MICROCHIP dsPIC33EPXXXGM3XX/6XX/7XX FAMILY

dsPIC33EPXXXGM3XX/6XX/7XX Family Silicon Errata and Data Sheet Clarification

The dsPIC33EPXXXGM3XX/6XX/7XX family devices that you have received conform functionally to the current Device Data Sheet (DS70000689D), except for the anomalies described in this document.

FIGURE 1: TIMING DIAGRAMS FOR CENTER-ALIGNED AND EDGE-ALIGNED MODES

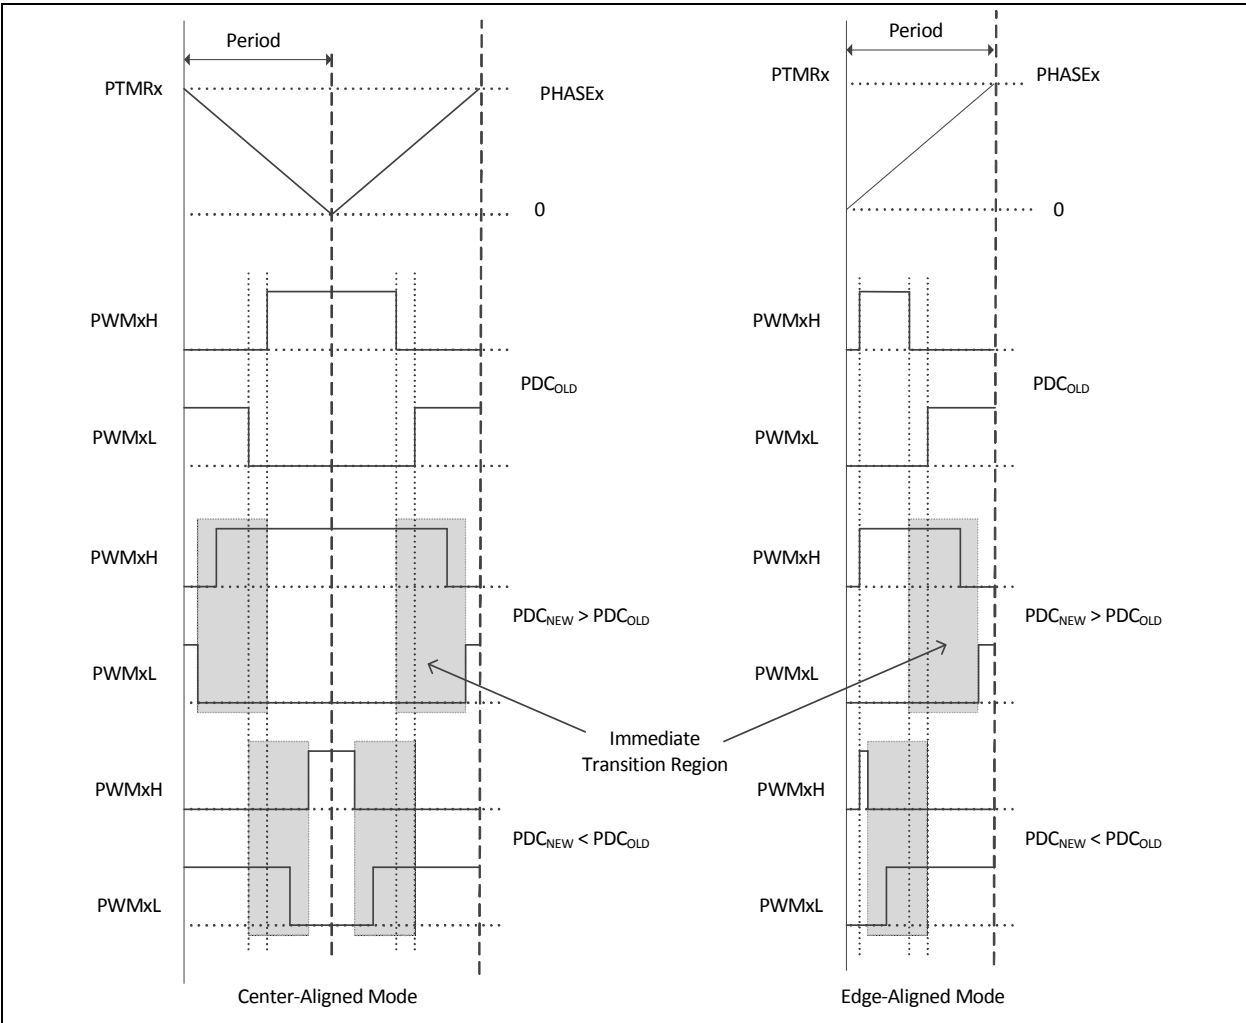
The PWM generator may not assert dead time on the edges of transitions. This has been observed when all of the following conditions are present:

- The PWM generator is configured to operate in Complementary mode with Independent Time Base (ITB) or master time base;
- Immediate update is enabled; and
- The value in the PDC register is updated in such a manner that the PWMxH and PWMxL outputs make an immediate transition.

The current duty cycle, PDC_{OLD}, newly calculated duty cycle, PDC_{NEW}, and the point at which a write to the Duty Cycle register occurs within the PWM

time base, will determine if the PWMxH and PWMxL outputs make an immediate transition. PWMxH and PWMxL outputs make an immediate transition if the Duty Cycle register is written with a new value, PDC_{NEW}, at a point of time when the PWM time base is counting a value that is in between PDC_{NEW} and PDC_{OLD}. Additionally, writing to the Duty Cycle register, close to the instant of time where dead time is being applied, may result in a reduced dead time which is effective on the PWMxH and PWMxL transition edges.

In Figure 1, if the duty cycle write occurred in the shaded box, then PWMxH and PWMxL will make an immediate transition without dead time.

None.

In most applications, the duty cycle update timing can be controlled using the TRIGx trigger, or Special Event Trigger, such that the above mentioned conditions are avoided altogether.

FIGURE 2: PWM GENERATOR TIMING DIAGRAM

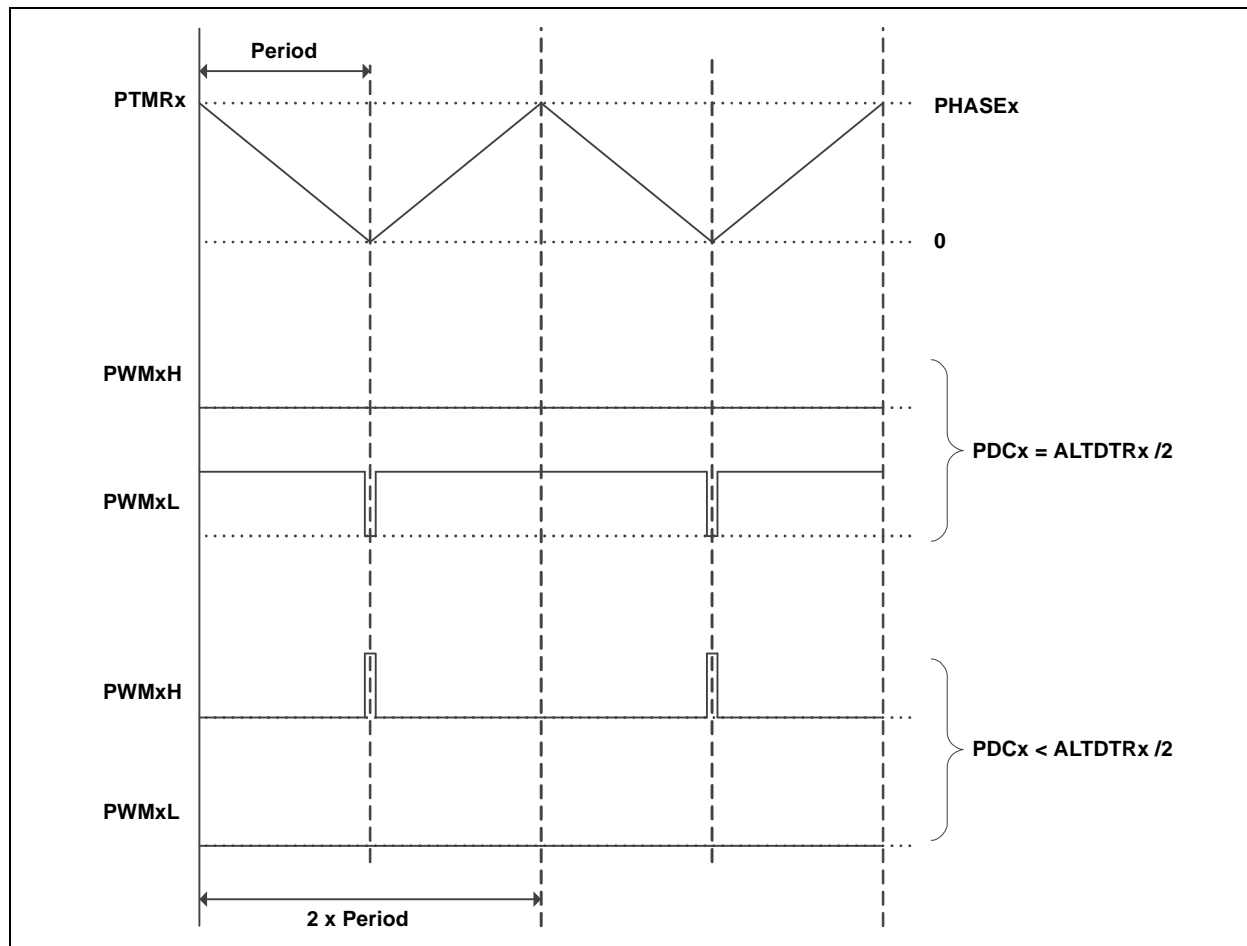
In Center-Aligned Complementary mode with Independent Time Base, if the value in the PDCx register is less than one-half the value in the ALTDTRx register, the PWM generator will force the PWMxL to low, and on the PWMxH, generates pulses of a width less than twice the dead time, as shown in Figure 2.

Include a software routine to ensure that the duty cycle value written to the PDCx register is at least one-half of the value in ALTDTRx. Example 1 shows one method, with PDCtemp representing the variable which has the value to be written to the PDCx register. Alternatively, for duty cycle values less than half the desired dead-time value, zero out the ALTDTRx register or dynamically reduce the value in the ALTDTRx register, such that ALTDTRx is always equal to $2 * PDCx$, as shown in Example 2.

```
Altdtr_by2 = ALTDTRx / 2;
if (PDCtemp < Altdtr_by2)
{
    PDCx = Altdtr_by2;
}
else
{
    PDCx = PDCtemp;
}
```

FIGURE 3:

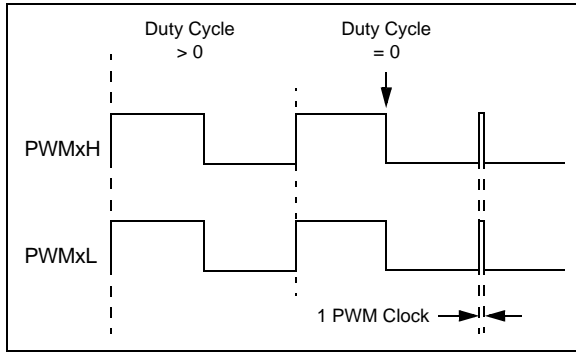
In certain output modes, the PWMx module produces a pulse glitch of one PWM clock in width (Figure 3). This has been observed only when all of the following are true:

- Either Redundant or Push-Pull Output mode is selected ($\text{IOCONx}<11:10> = 10$ or 01);
- Immediate Update is disabled ($\text{PWMCONx}<0> = 0$); and
- The value of the current Duty Cycle register (either the PDCx or MDC register, as determined by $\text{PWMCONx}<8>$) is updated to zero from any non-zero value.

The pulse glitch has been observed to occur at the beginning of the following PWM boundary period.

If the application requires a duty cycle of zero, two possible work arounds are available.

1. Use the PWM overrides to force the output to a low state, instead of writing a '0' to the Duty Cycle register. When using this method, the PWM override must be disabled when the duty cycle is a non-zero value. If output override synchronization is configured to occur on CPU clock boundaries ($\text{IOCONx}<0> = 0$), enabling and disabling the override must be timed to occur as closely as possible to the PWM period boundary.
2. Configure the module for Immediate Update ($\text{PWMCONx}<0> = 1$) *before* enabling the module. In this mode, writes to the Duty Cycle register have an immediate effect on the output. As with the previous work around, writes to the Duty Cycle register must be timed to occur as close to the PWM period boundary as possible in order to avoid distortion of the output.

FIGURE 4:

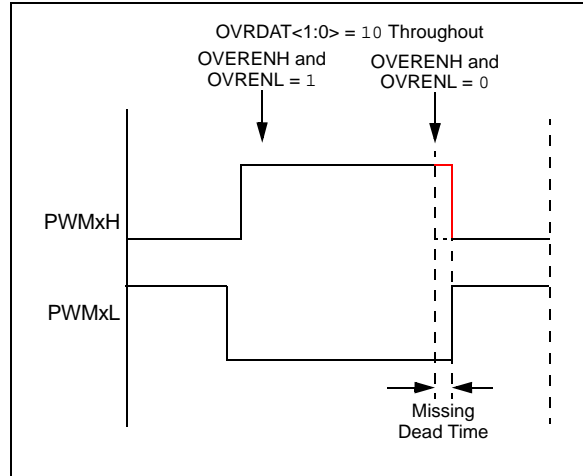
In Complementary Output mode, the expected dead time between transitions of the PWMxH and PWMxL outputs may not be asserted when the following occurs:

- Output override synchronization is configured to occur on the CPU clock boundary ($\text{IOCONx}<0> = 0$);
- Both PWMxH and PWMxL overrides are enabled prior to the event (OVRENH and OVRENL are both '1'), and
- Both overrides are disabled (OVRENH and OVRENL are both '0') at the instant the dead time should be asserted (Figure 4).

This has been observed in both Center-Aligned and Edge-Aligned modes.

None.

FIGURE 5:

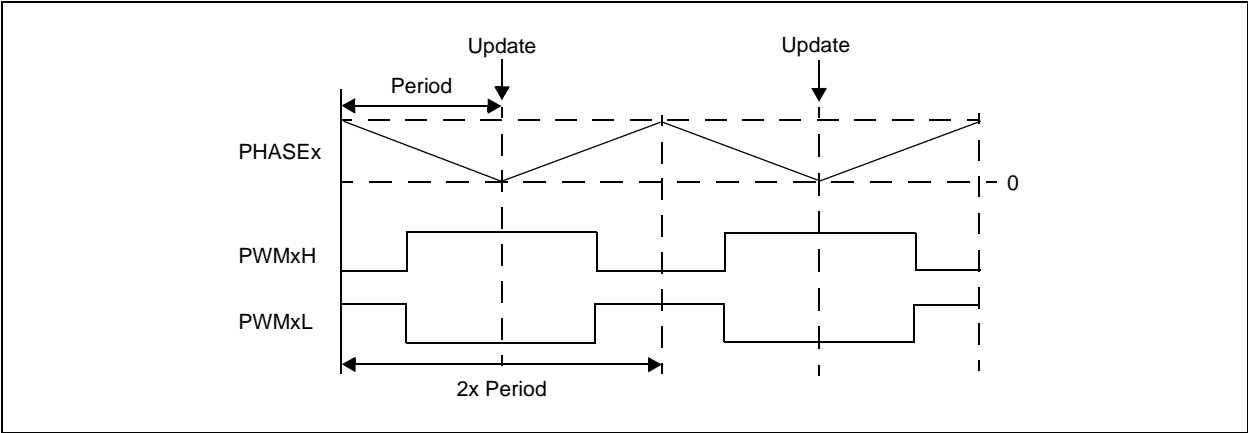
In Center-Aligned Complementary mode with Independent Time Base, updates to the PHASEx register take effect in the middle of a Center-Aligned PWM cycle, as shown in Figure 5. This occurs only when the Immediate Update feature is disabled (IUE = 0). If Immediate Update is enabled (IUE = 1), the PHASEx register updates will take effect immediately.

None.

FIGURE 6:

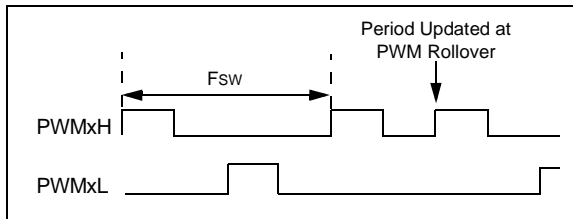
When the PWM module is configured for Push-Pull mode (IOCONx<11:10> = 10) with the Enable Immediate Period Update bit enabled (PTCON<10> = 1), a write to the Period register that coincides with the period rollover event may cause the push-pull output logic to produce back-to-back pulses on the PWMx pins (Figure 6).

Ensure that the update to the PWM Period register occurs away from the PWM rollover event by setting the EIPU bit (PTCON<10> = 1). Use either the PWM Special Event Trigger (SEVTCMP) or the PWM Primary Trigger (TRIGx) to generate a PWM Interrupt Service Routine (ISR) near the start of the PWM cycle. This ISR will ensure that period writes do not occur near the PWM period rollover event.

64-Lead Plastic Quad Flat, No Lead Package (MR) – 9x9x0.9 mm Body with 5.40 x 5.40 Exposed Pad [QFN]

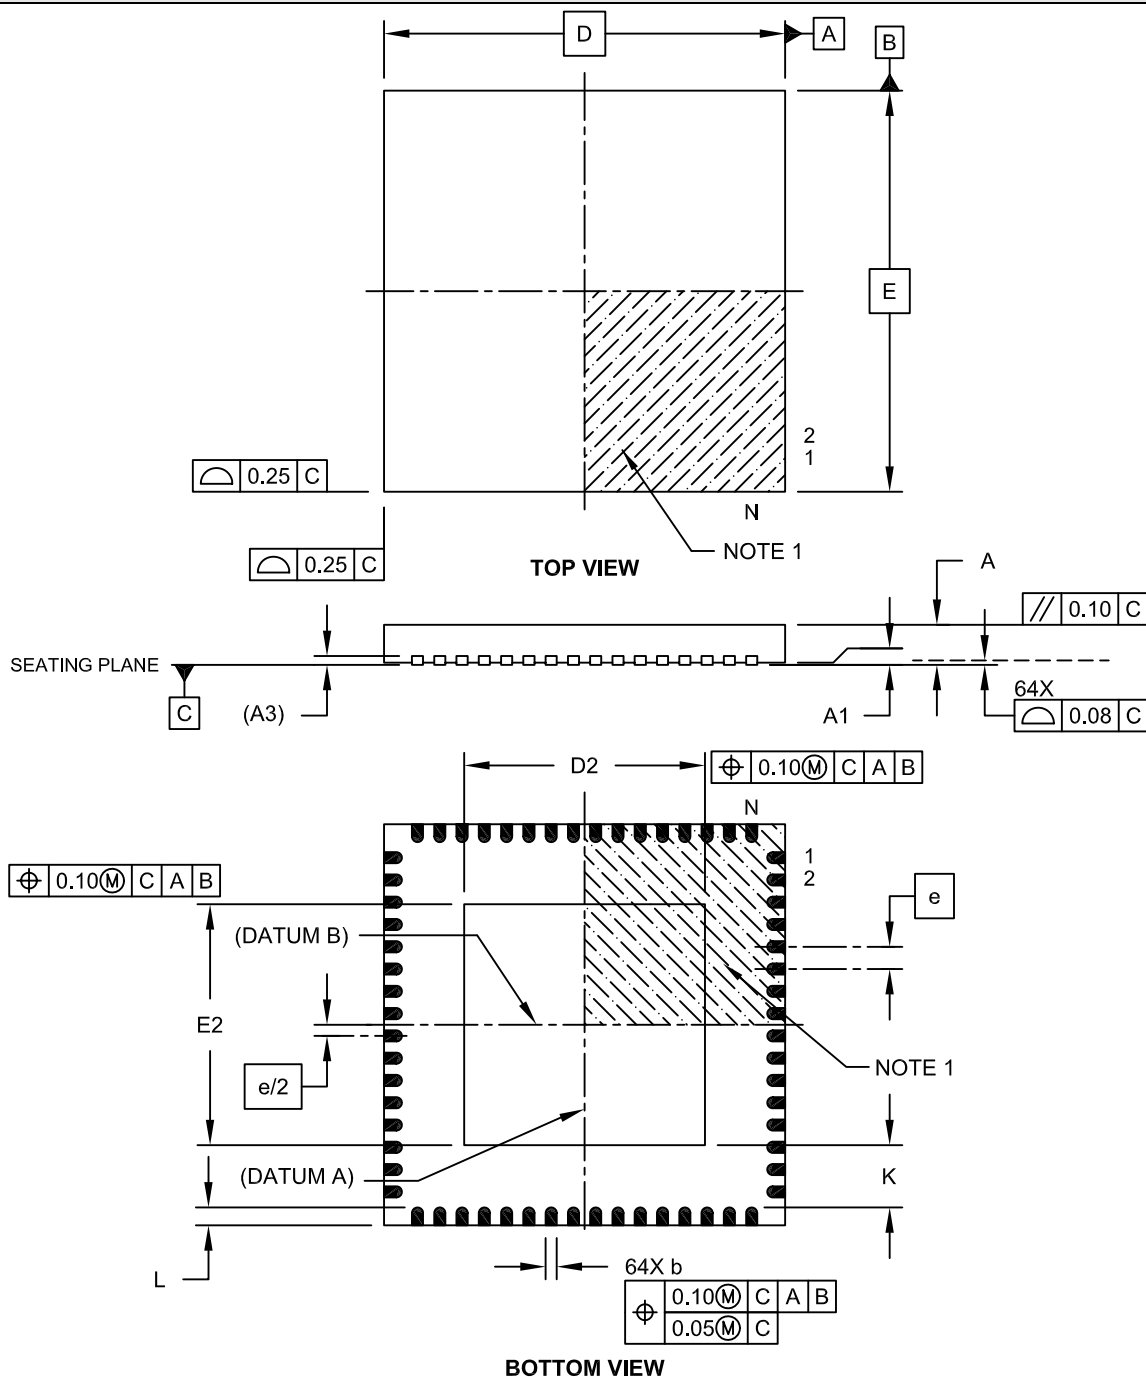
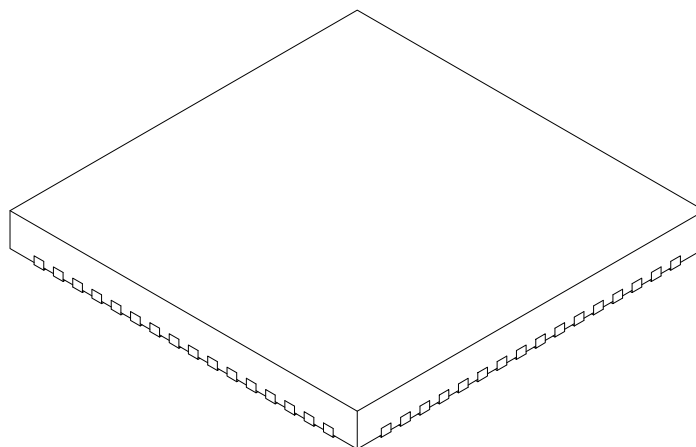
In the “dsPIC33EPXXXGM3XX/6XX/7XX Family Data Sheet”, **Section 35.2 “Package Details”**, dimensions for the 64-Lead Plastic Quad Flat, No Lead Package (MR) – 9x9x0.9 mm Body with 7.15 x 7.15 Exposed Pad [QFN] is mentioned. However, the dsPIC33EPXXXGM3XX/6XX/7XX family devices are not available in this package.

The dsPIC33EPXXXGM3XX/6XX/7XX family devices are available in the 64-Lead Plastic Quad Flat, No Lead Package (MR) – 9x9x0.9 mm Body with 5.40 x 5.40 Exposed Pad [QFN], and the package dimensions are shown on the following pages.
